## Objection to the Uniting Kingscliff Redevelopment (SSD-47105958)

### My concerns with formulating my objection are as follows

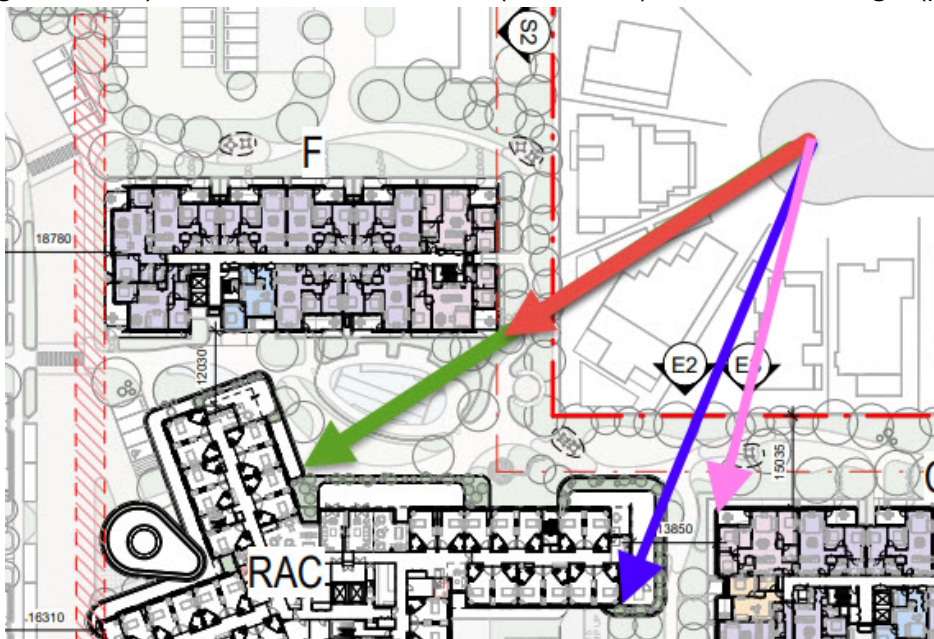
The first image is of my own house that has been misinterpreted and this image is taken from the DA.

If standing in the street not only do you see building F (red arrow) , you should also to be able to see RAC building (green arrow) to the north west and west (blue arrow) as well as Building C (pink arrow)

Surely such an important image where not only one building, but two other buildings be also seen in the photograph and below is what should be able to be seen

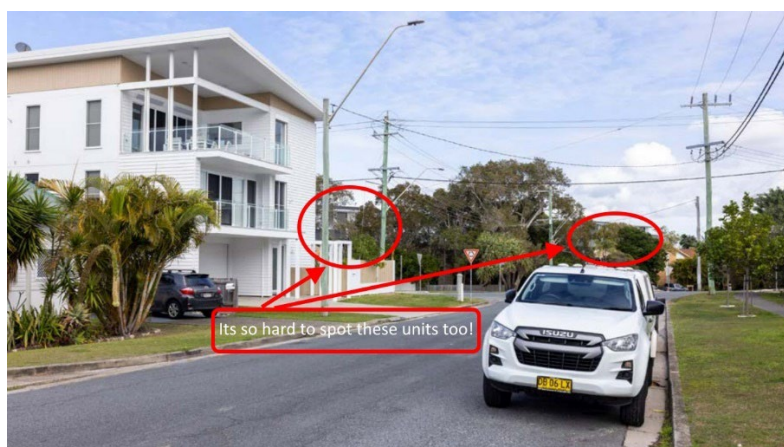
Then when we look at the backyard photomontage of 37 Drift Court at first sight it seems that this property is only affected by one building.

However its misleading for the image has the second building hidden mostly by the outdoor verandah roof. It is not co-incidental; its just wrong and its deceiving.

Surely the photographer should have taken it from the glass pool fence if they weren't to deceive the public of the real impact of both buildings.

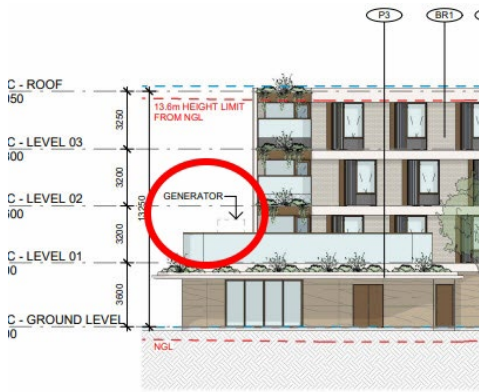
No indication in plans to prevent light transmission to surrounding properties.

Directly behind my property there are 36 individual high care rooms (12 units per floor x 3 floors) plus dining and lounge rooms and 3 large terrace style balconies. It will be common of a night time for lights to be turned on as the elderly are cared for 24x7 and accessing bathrooms as well as receiving care during the night as well as lights turned on balconies. No provision has been given to preventing the lights in these rooms to be suppressed onto the surrounding homes, particularly my home which is the most affected

Light transmission has been a concern for some time on the current Uniting site and when we look across to the current carpark there is only two carpark lights in operation (from the 6 light poles) for Uniting are unable to shield the light from transmitting onto neighbouring properties. Whats the plan for preventing light transmission for the new project to surrounding established homes?

04.2 Section & Elevation  
Section 02 - Building F

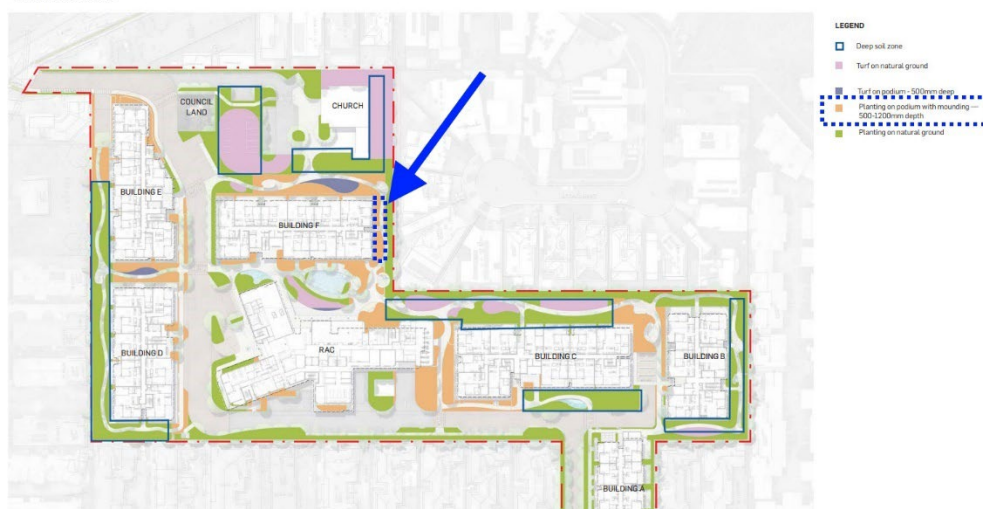
Then we look again at the cross section close up and its on the plan above but not indicated on any cross sections of buildings. Admittedly its right on the boundary however the plans show the subdivision on the other side of the concrete but not the height of the drain.

Above is the difference in height between the rear of 39 and 41 Drift Court with a drop of 1250mm to the drainage easement and the fall is greater as it goes to the lowest point behind

Then there is no detail at all in this cross section. There is a lack of detail on what sort of fences is Uniting intending on installing? It should no doubt be an acoustic fence for if there are people

walking on the other side of the fence', we should not be able to hear them. And no doubt it will not be one or two people walking there, it could be hundreds of a weekend when you not only consider residents but also visitors and friends and family to not only the high care building but also to the residential buildings and pool area/ grounds and gardens all of which are centered around the rear of Drift Ct cul-de-sac. Then there are 120 people using the pool area as well that have to return to their apartments most likely along the pathways directly behind our property.

ground level for building F below

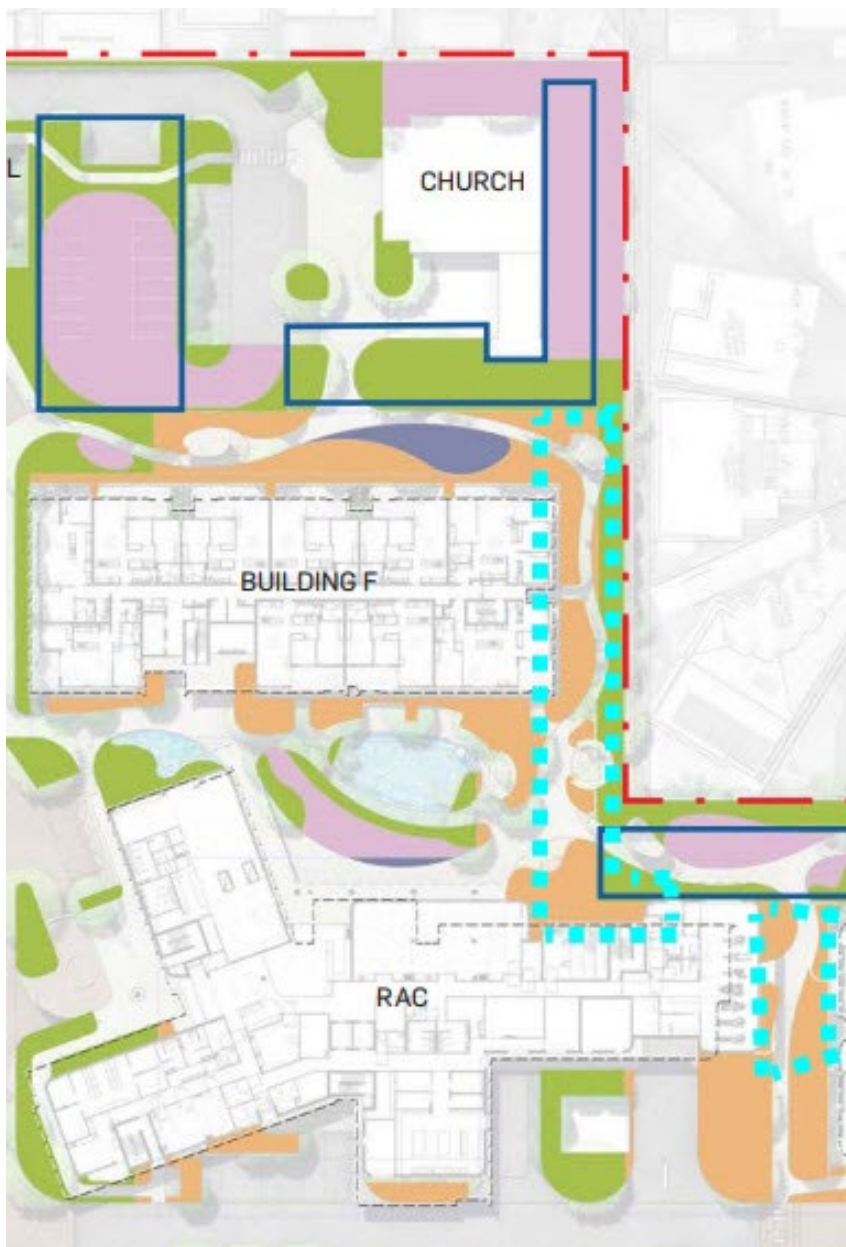
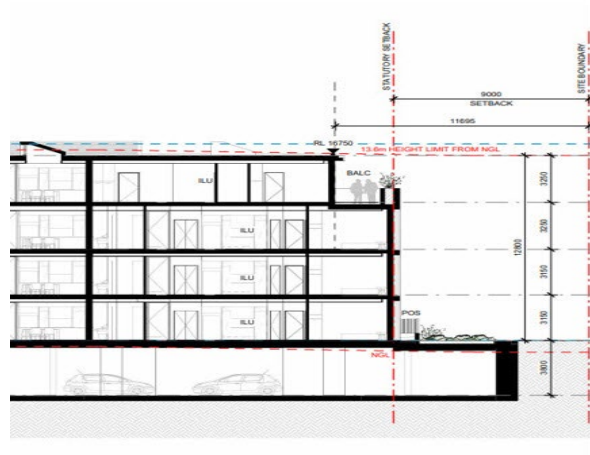
Then when we look at the planting structure diagram there a lack of data surrounding the trees being able to survive in only up to a mound of dirt on the southern side of block F that will be in full

shade with no drainage underneath that is on top of a carpark. The image below shows that the orange section will have planting on podium with mounding 500-1200 depth

Below is the cross section of the same building showing no mounding at all and no drainage to the basement carpark below.

If trees of over 6m in height that will be a part of the high canopy cover will not grow with a basement carpark directly below. If they mound the dirt to 500-1200, why is the mounding not in the cross section below because that is a significant tree and mound. I have indicated where these mounds are that affect 39 and 41 Drift Court in Light Blue. They have plants shown on the top floor balcony, yet no advanced planting of trees or mounding. The evidence is inaccurately presented. And again, no drainage easement not shown in the site boundary. More missing data

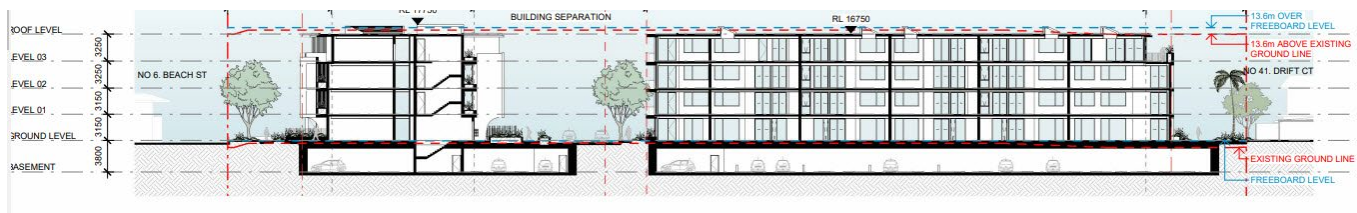
Then there is another artists impression where it looks as if advanced pandanus plants seem to have been planted in the drain location (refer to section 02 building F illustration above) and that the plantings are actually so dense they are pushing up against our back fence. Another inconsistent property view, considering there is another fence on the other side the drain 80cm away.
